ELIOT QUARRY (SMP-23) RECLAMATION PLAN AMENDMENT

FINAL SUBSEQUENT ENVIRONMENTAL IMPACT REPORT
CHAPTERS 1—7 AND APPENDICES

Lead Agency
Alameda County, Community Development

Benchmark Resources
2515 East Bidwell Street, Folsom, CA 95630

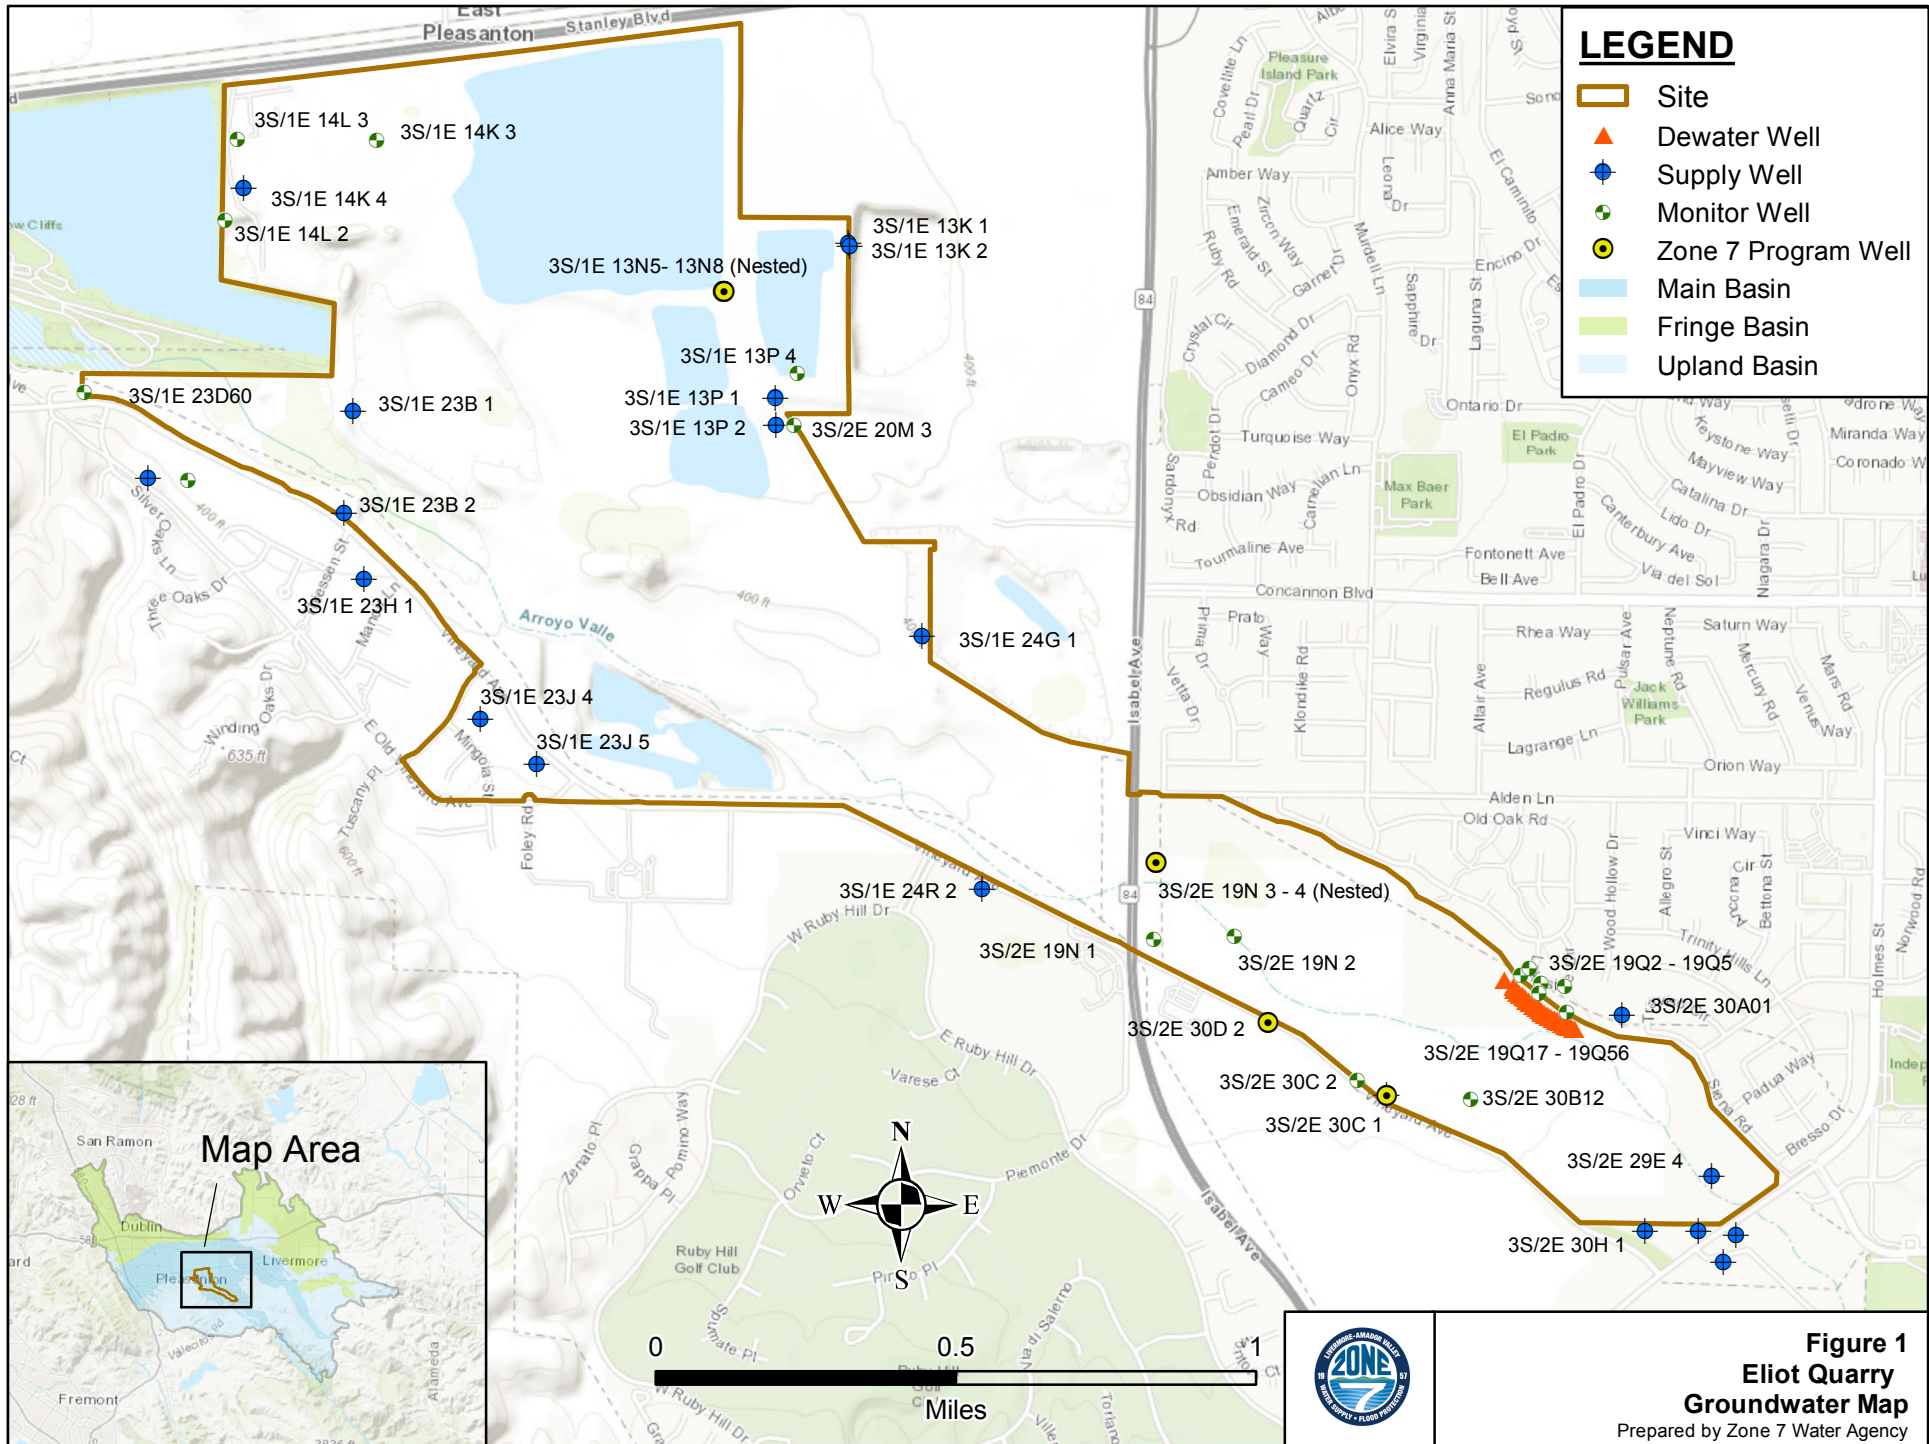
The water quality assessment was performed based on "average" concentrations of constituents of concern, without giving any consideration to maximum detected concentrations in the area. For example, utilizing average concentrations for Hexavalent Chromium (Cr6) indicates no need for any mitigation measures. But examples from where active mining has taken place, the maximum concentrations for location R24 is 17 ug/l and P42 is 9.6 ug/l. These indicate that some mitigation/monitoring is necessary in active pits – likely due to the release of metals such as chromium, iron, and manganese from the scraping of the surface of soils and rocks during mining.

Therefore, we have the following recommendations for additional mitigation measures:

- i). Recommended mitigation: Flexibility should be built into the mitigation measures to address changes in MCLs and/or to address contaminants of emerging concern, such as Per- and Polyfluoroalkyl Substances (PFAS) and Hexavalent Chromium (Cr6).

- ii). Recommended mitigation: CEMEX to prepare an updated water quality assessment every five years to incorporate Zone 7 Groundwater Sustainability Plan updates and/or new or revised drinking water MCLs and mitigate any associated impacts.

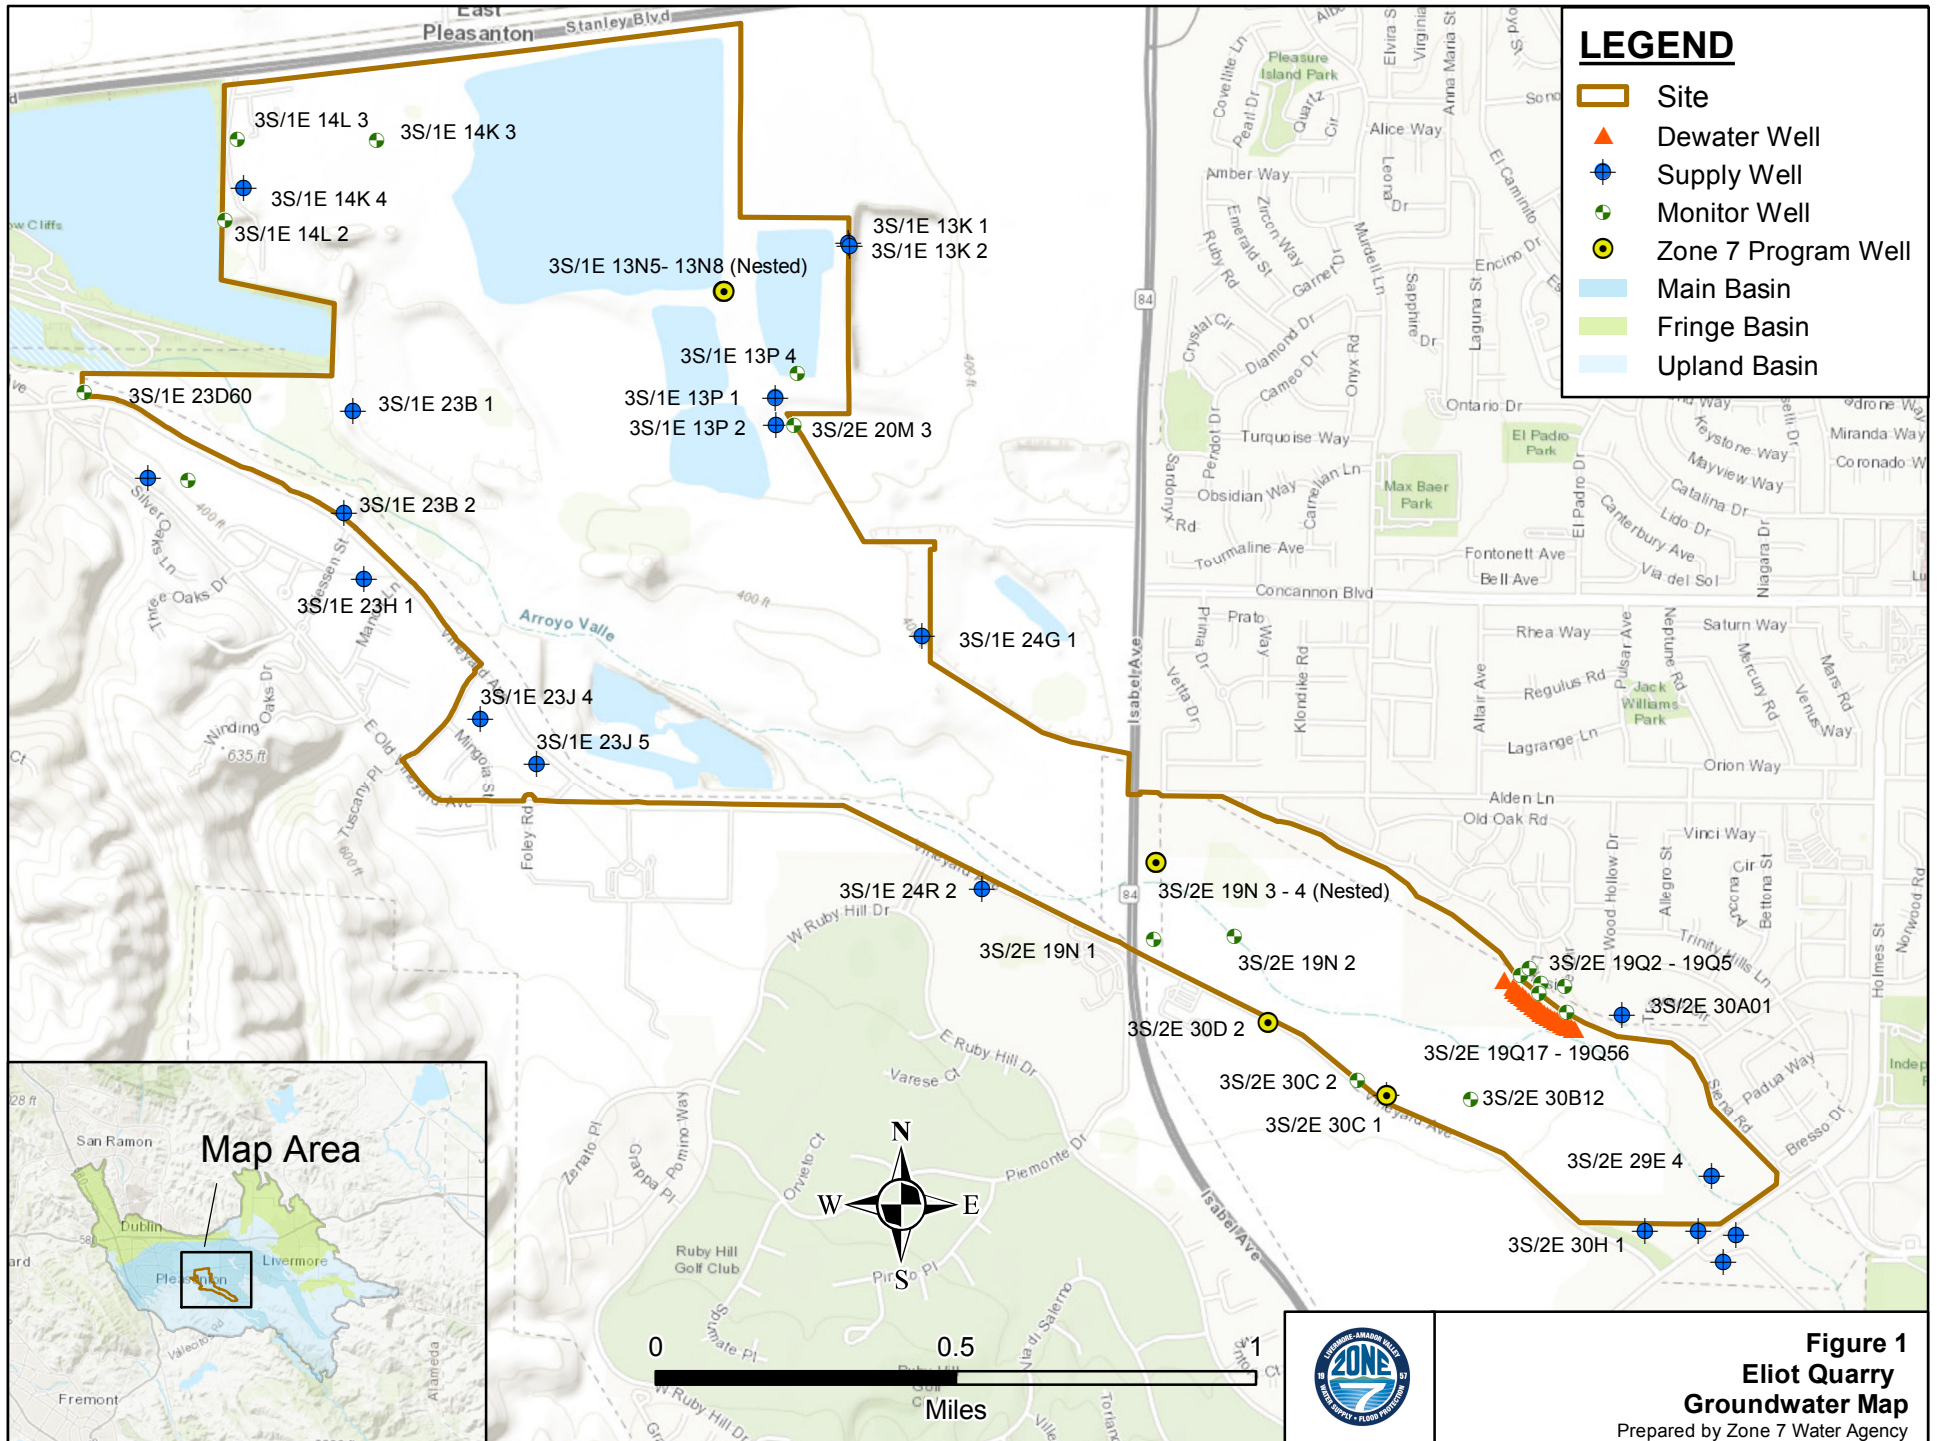
The water quality assessment was performed based on "average" concentrations of constituents of concern, without giving any consideration to maximum detected concentrations in the area. For example, utilizing average concentrations for Hexavalent Chromium (Cr6) indicates no need for any mitigation measures. But examples from where active mining has taken place, the maximum concentrations for location R24 is 17 ug/l and P42 is 9.6 ug/l. These indicate that some mitigation/monitoring is necessary in active pits – likely due to the release of metals such as chromium, iron, and manganese from the scraping of the surface of soils and rocks during mining.

Therefore, we have the following recommendations for additional mitigation measures:

- i). Recommended mitigation: Flexibility should be built into the mitigation measures to address changes in MCLs and/or to address contaminants of emerging concern, such as Per- and Polyfluoroalkyl Substances (PFAS) and Hexavalent Chromium (Cr6).

- ii). Recommended mitigation: CEMEX to prepare an updated water quality assessment every five years to incorporate Zone 7 Groundwater Sustainability Plan updates and/or new or revised drinking water MCLs and mitigate any associated impacts.
